Author's response to review 1

This paper by Reum et al., presents a new atmospheric observatory for CO₂ and CH₄ in the Siberian coastline. The presence of this new research infrastructure is a very valuable opportunity for the atmospheric science community, especially taking into account the possible role that carbon stocks in the arctic region (i.e. permafrost melting) can play in the next decades under the current climate change.

Fig. 1: Wet air mole fractions vs water vapor from the water correction experiments presented in the main text of the manuscript. The data from the three droplet experiments are shown with the same color.

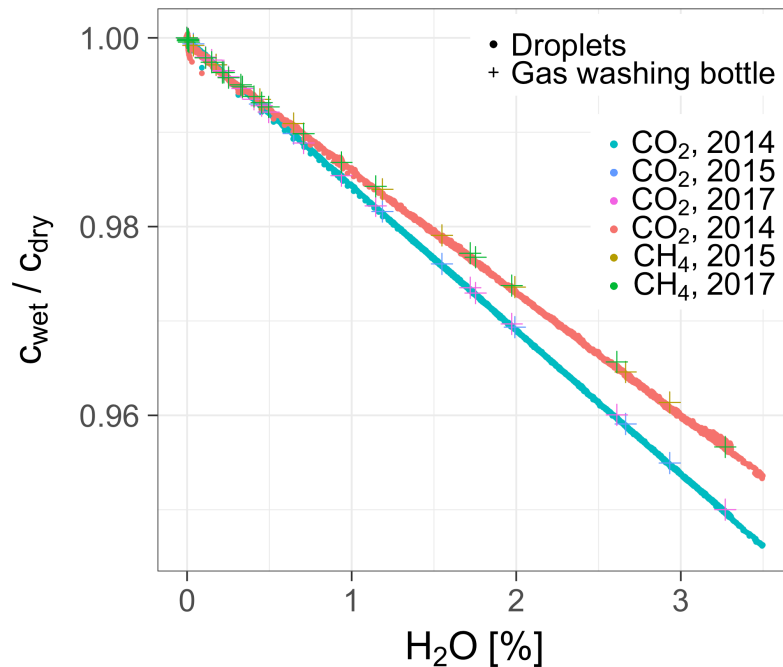
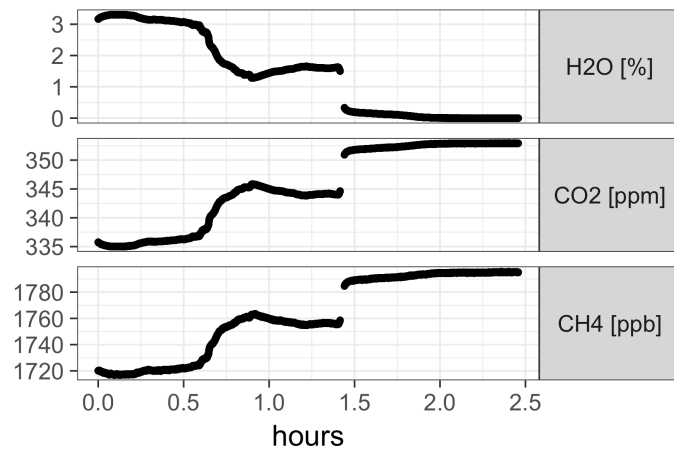
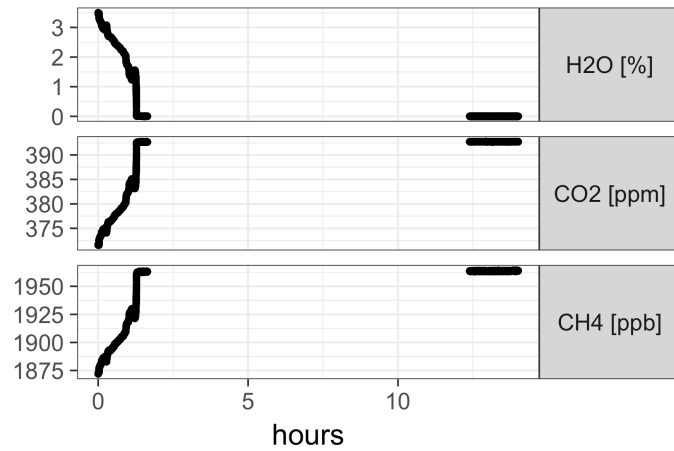
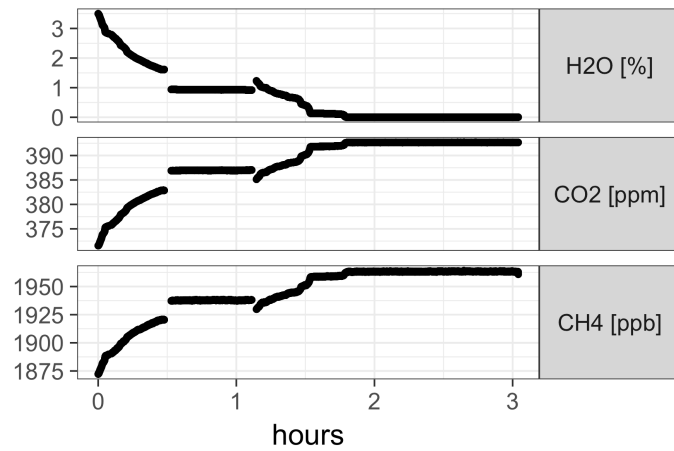
It is possible to add in the supplementary material more info about the water vapour test? E.g. plot of Concentration(wet)/Concentration(dry) ratios plotted as function of water vapour level for CO₂ and CH₄ or time series of CO₂wet, CH₄wet during the water correction experiment. I'm wondering which is the absolute difference (in ppm and ppb for CO₂ and CH₄) if the "classical" water droplet experiment is used instead the Reum et al. (20q8) procedure. I'm pretty sure that this difference is well lower than the WMO compatibility goals.

The requested plot of wet air- over dry air mole fractions is given below (Fig. 1). However, as the reviewer pointed out, the differences between the methods are small and hardly visible in this type of plot. Because of this, and since the gas washing bottle data were presented in more detail in Reum et al. (2019), we chose to present the differences between the experiments with the Ambarchik system as in Fig. 4 in our manuscript. The plot below is not suitable to present the differences between the methods. Therefore, we prefer not to include it in the manuscript.

Fig. 3: Running standard deviations of Target tank data averaged over 13 days (used for estimating LTR).

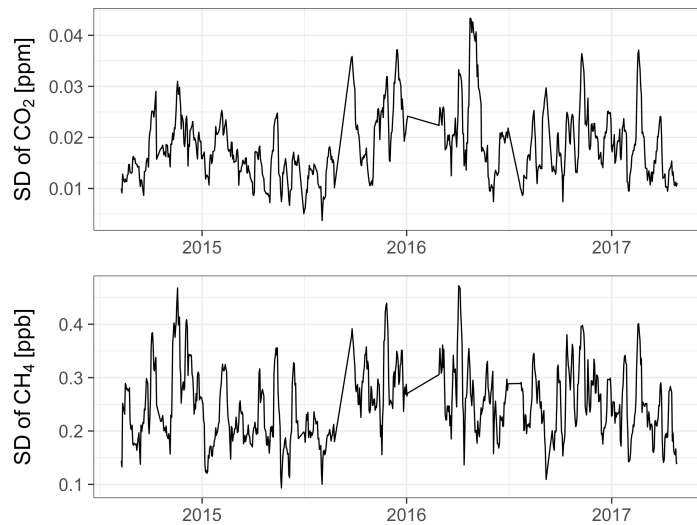
Can you provide the time series of standard deviation (based on 1-minute averages) of single target measurements (a measure for the CMR) and the time series of the standard deviation over 72 hours of the target gas injection means (LTR)?

In Yver Kwok et al. (2015), CMR and LTR were defined as average values, not as timeseries. Here, we first provide values according to those definitions, and then time series as requested by the reviewer. We did not perform measurements that follow precisely the protocol in Yver Kwok et al. (2015). However, a similar value as LTR is already incorporated in our uncertainty estimates: as stated in Appendix E, analyzer drift and precision ($\sqrt{u_p^2 + u_b^2}$) were jointly estimated from a dry air measurement in the lab prior to field deployment that lasted 12 days. More precisely, analyzer drift and precision of hourly values were calculated as the standard deviation of hourly averages over this 12-day measurement and was reported in the manuscript (0.013 ppm CO₂, 0.25 ppb CH₄). This is somewhat similar to the LTR by Yver Kwok et al. (2015), which was defined as the standard deviation of 10-min averages over a period of 3 days. Alternatively, one may use the regular target gas injections for computing a measure for LTR. To obtain a meaningful standard deviation, more than 72h have to be considered, since measurements take place only every 29h. Therefore, we show the timeseries of the standard deviation over 13 days, which corresponds to 11 regular Target tank measurements. We use the averages of the final 2 min of each target tank measurement that were used to calibrate data (Fig. 3). The average LTR estimated this way is 0.018 ppm CO₂ and 0.25 ppb CH₄.

Fig. 5: Timeseries of CO₂ and CH₄ values from gas tank measurements. Shown here are the last two minutes of each gas tank measurement, i.e. the values that were used to derive calibration coefficients.

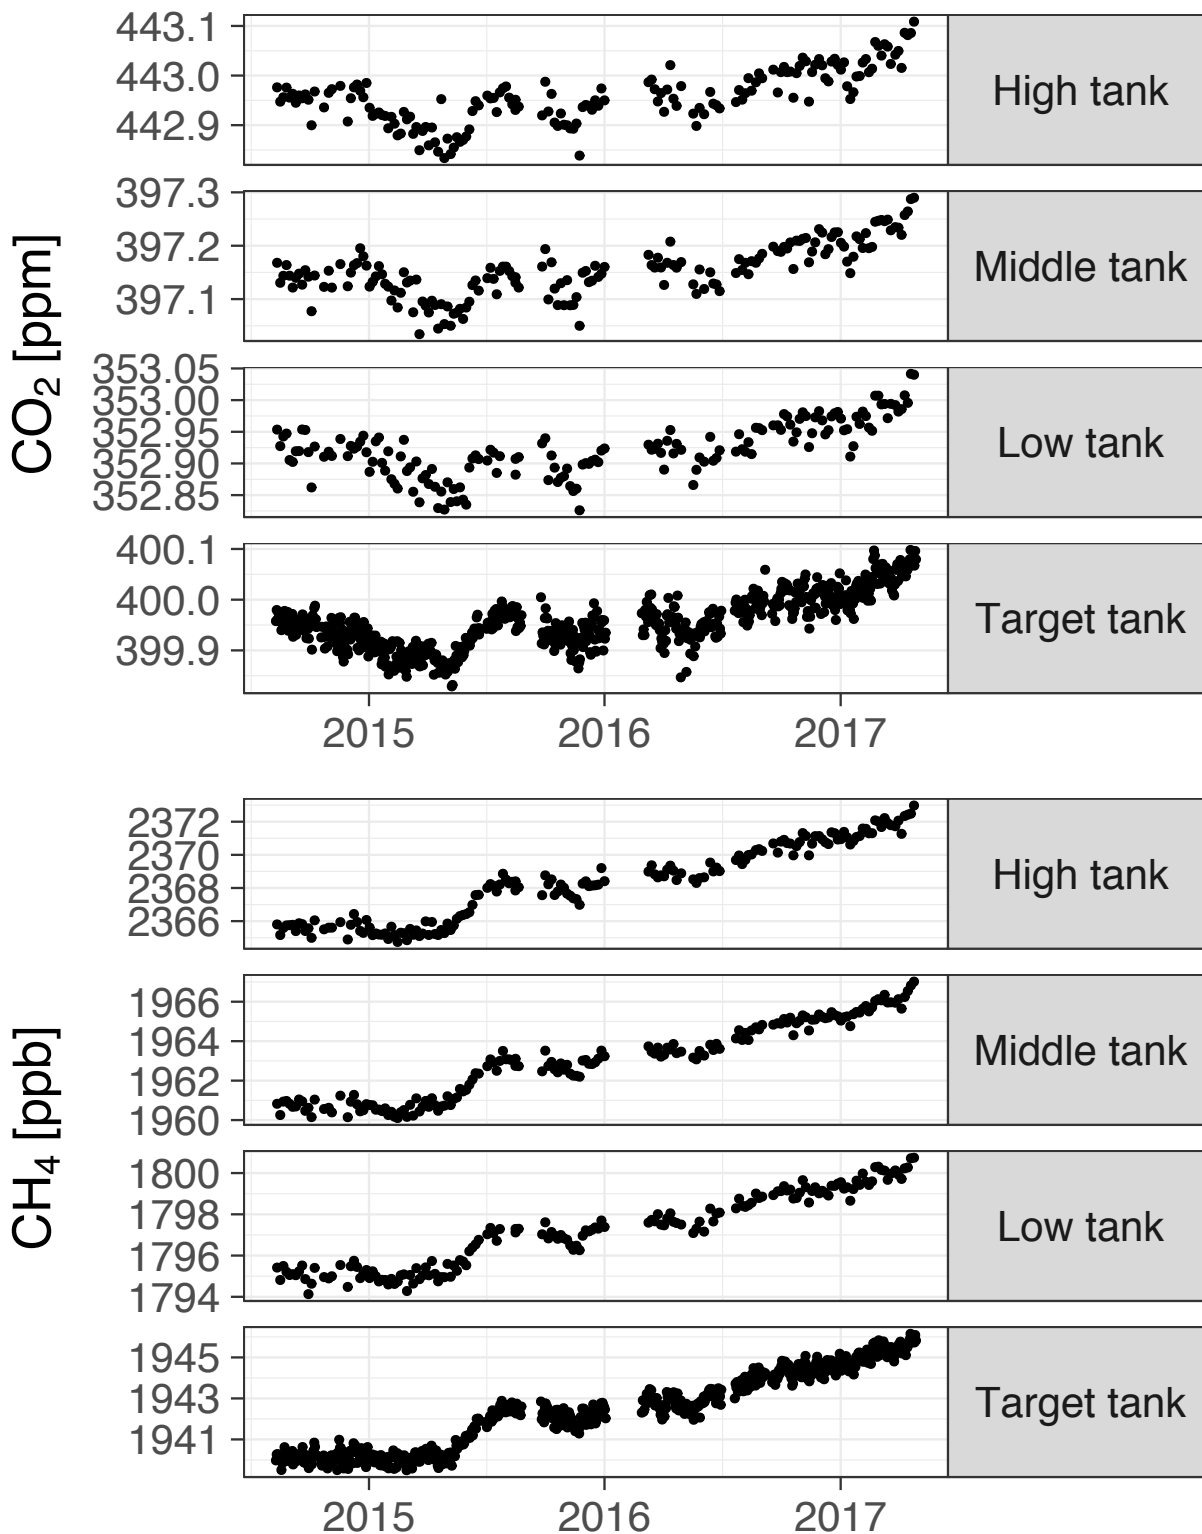
The spread of intercept looks pretty high (for both CO2 and CH4). Please can you provide the time series of measurement results (expressed as average value of CO2 and CH4) for each single tank during the calibration events?

The spread of the intercept represents the uncertainty for theoretical measurement values of 0 ppm CO2 and 0 ppb CH4. The uncertainty in the range covered by the calibration tanks (and

thus, typical ambient mole fractions) is much smaller and quantified by se_{fit} , which, if computed for individual calibration events, would on average be 0.047 ppm CO₂ and 0.11 ppb CH₄. For more details, see also the difference between σ_b and $\sigma_{b,min}$ explained in Andrews et al. (2014). The requested plot is shown in Fig. 5 below.

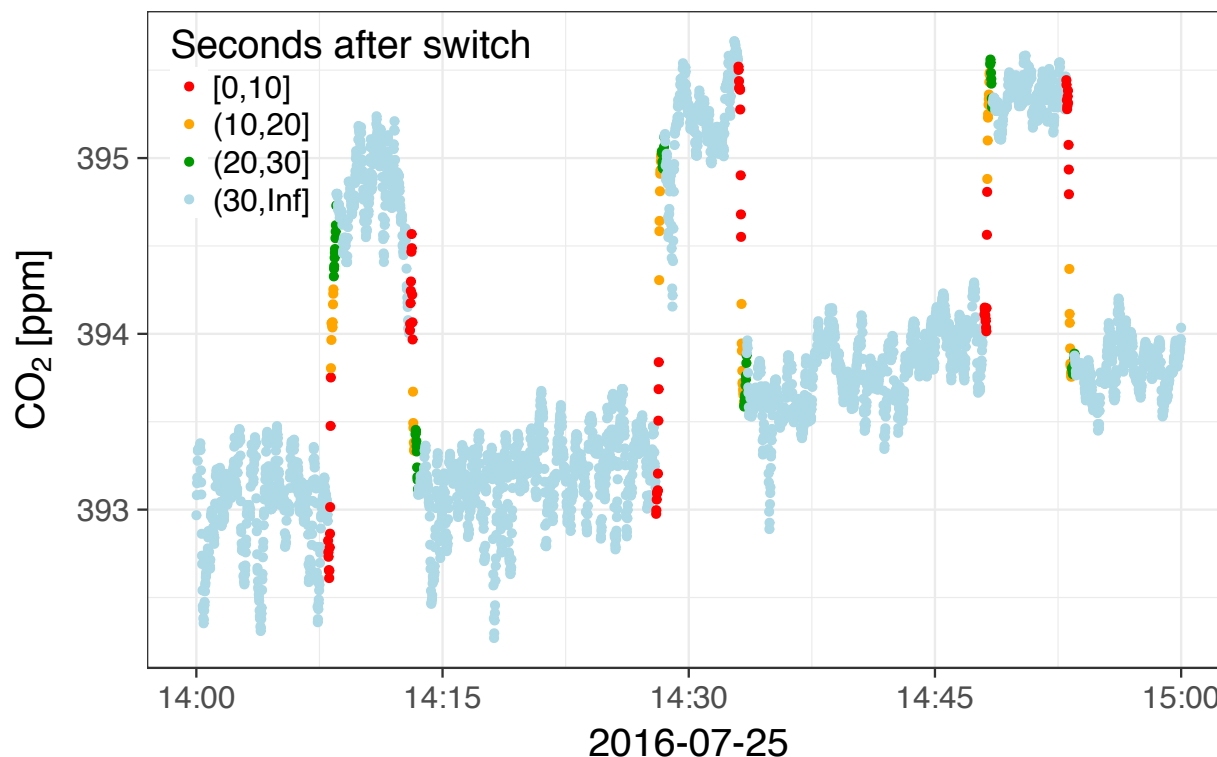
-3.4.2 Flushing of the measurement 30 sec is not sufficient as stabilization time. I think that a few minutes is more suitable.

To avoid misunderstandings, the 30 seconds were only used for switching between ambient air inlets. After switching from tanks to ambient air inlets, 5 minutes of flushing were used to account for the much larger differences in CO₂, CH₄ and H₂O mole fractions between gas tank and ambient measurements. We agree with the reviewer that longer flushing of the lines reduces chances of cross-contamination between air sources. However, the purpose of switching between the two inlets is to be able to filter for situations where differences between the two inlets are large. In cases when the differences are large, the timing of trace gas changes when switching between inlets can be observed and is roughly as follows (an example is given in Fig. 6): after ~8 seconds, recorded values start changing rapidly (i.e. this is the residence time between V1 and Picarro cavity). This rapid change lasts for roughly ~10 seconds. Afterwards, changes are small. Certainly not all cross-influence will be removed by then, but since our intention is to detect cases of large differences between the inlets for the purpose of filtering them out, we think that 30 seconds of flushing are sufficient.

Fig. 7: Fraction of data affected by the CO2 spike flagging. Shown here are data that pass the temperature gradient and wind speed filter from Table 3 of the manuscript.

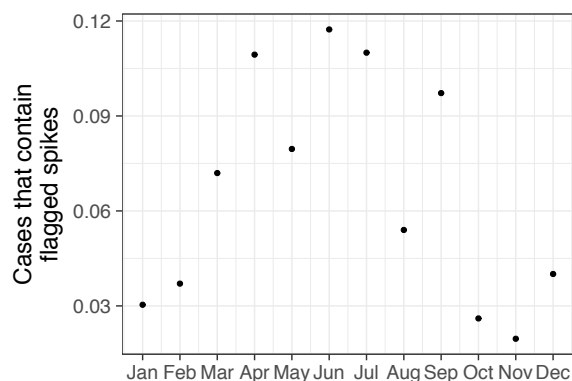
Table 3: the statistic is referring to all data or the 1-4 PM selection? Looking to Fig. 6, it seems that WD has a strong seasonal variability. How the fraction of flagged data is shared among the different months of the year?

Table 3 refers to all data (we add that to the caption of the table). The annual variation of the impact of the spike filter depends on whether filters are applied (Fig. 7 below).

Here, we present seasonal variations of the fraction of flagged data. We consider the case of applying the temperature gradient (“T”) and wind speed (“wv”) filter to remove the seasonally varying impact of temperature inversions and wind speed variations. The fraction of affected data follows indeed the wind speed pattern (Fig. 7): more data are affected during the period March–September than October–February. This roughly corresponds to the period when the prevailing wind direction is Northeast, where the inhabited building, and thus contamination sources are located.
